REMARKS

Appln. No. 10/754,505
Amdt dated November 15, 2005
Reply to Office Action of August 19, 2005

Amendments to the Drawings

Fig. 2

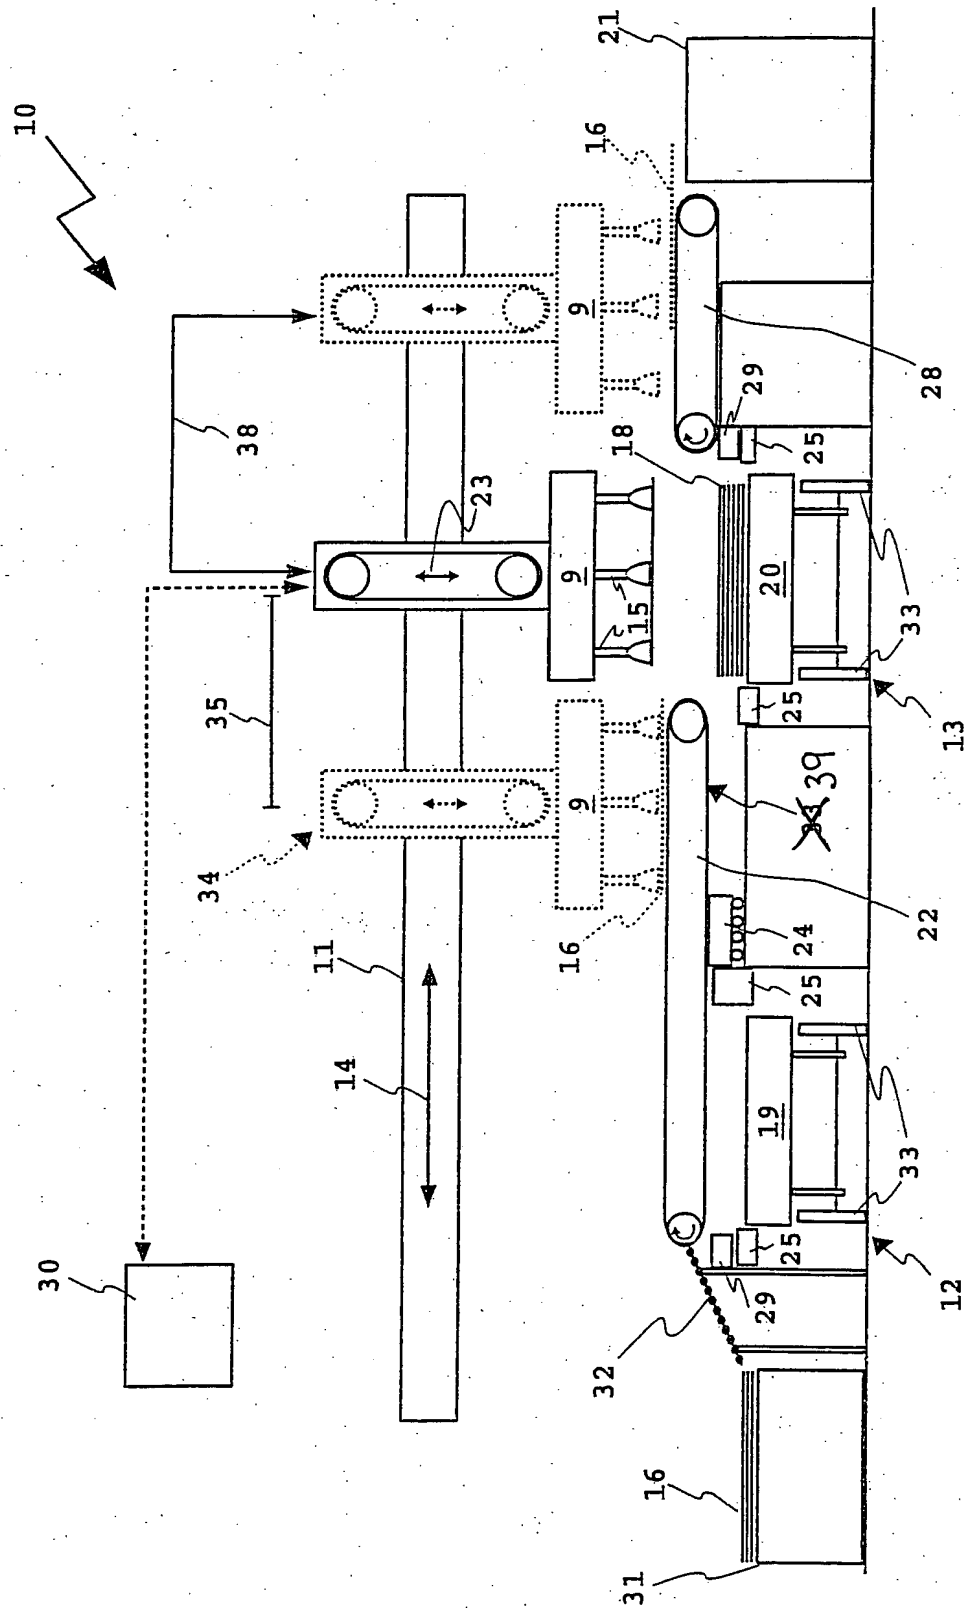
Applicant has, however, enclosed an amendment to Fig. 2, wherein the multiple use of numeral "33" has now been corrected by numbering the "second longitudinal position" as "39" rather than "33". Corresponding amendments have also been made on page 8 of the disclosure.

The attached sheet of drawings includes changes to Fig. 2. This sheet, which includes Fig. 2, replaces the original sheet including Fig. 2. In Fig. 2, the second longitudinal position "33" has been corrected to show "39".
